Response to a request for further information under section 92 of the Resource Management Act 1991

| Application Number: | BUN60433077 |
| Proposed Activity: | To construct a public pathway within Point England Reserve through to Wai O Taiki Reserve with associated earthworks, tree and vegetation removal. |
| Address: | 254 Point England Road, Point England |

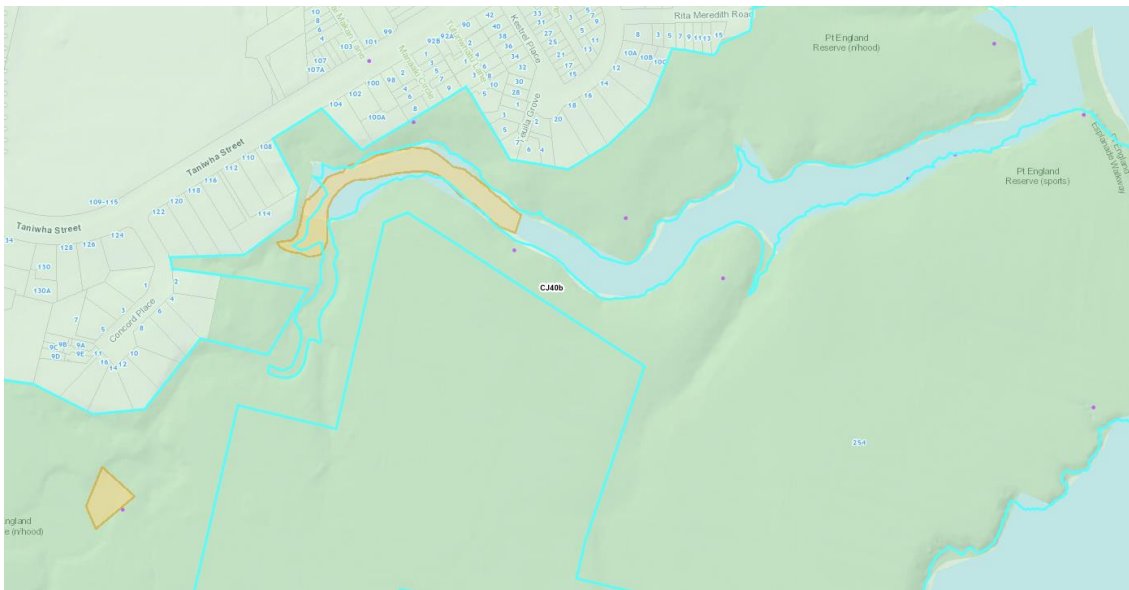
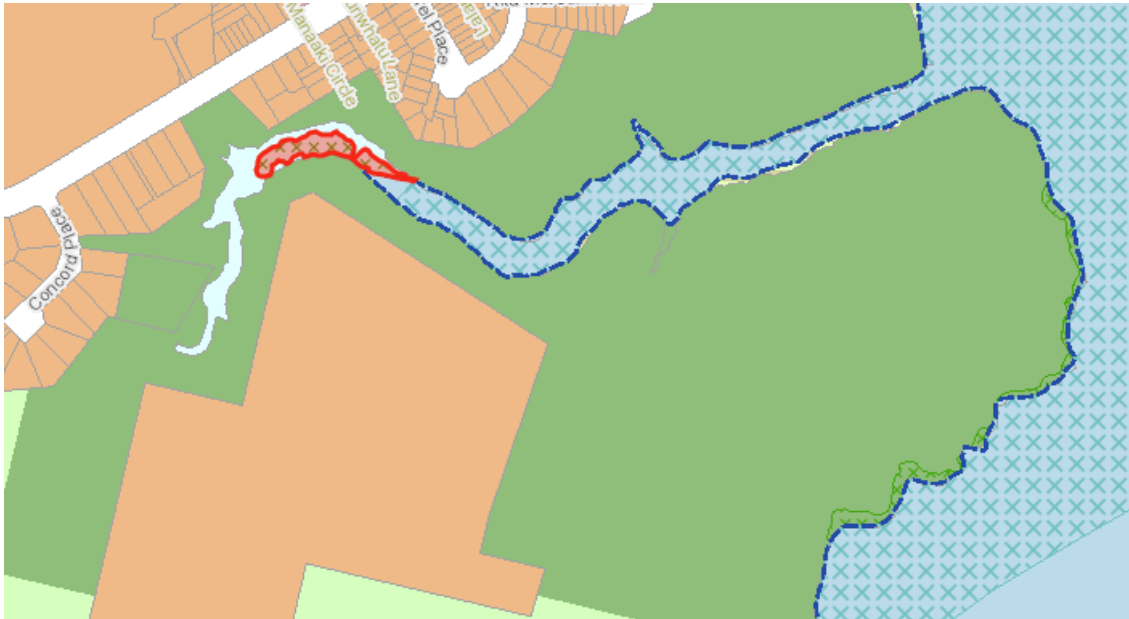
5. It has been identified that a portion of the Omaru Stream is classified as a Wetland. Please see attached plan. Due to the presence of the wetland and associated works, the proposal will trigger the following reasons for consent under the NES-F:

6. Please confirm if any works are occurring within both the SEA_T_3140, Terrestrial (in red) and wetland (in orange).

An initial response has been provided via email. Is question is related to question 16 below with a full response provided to that question.

No works are proposed in the areas identified.
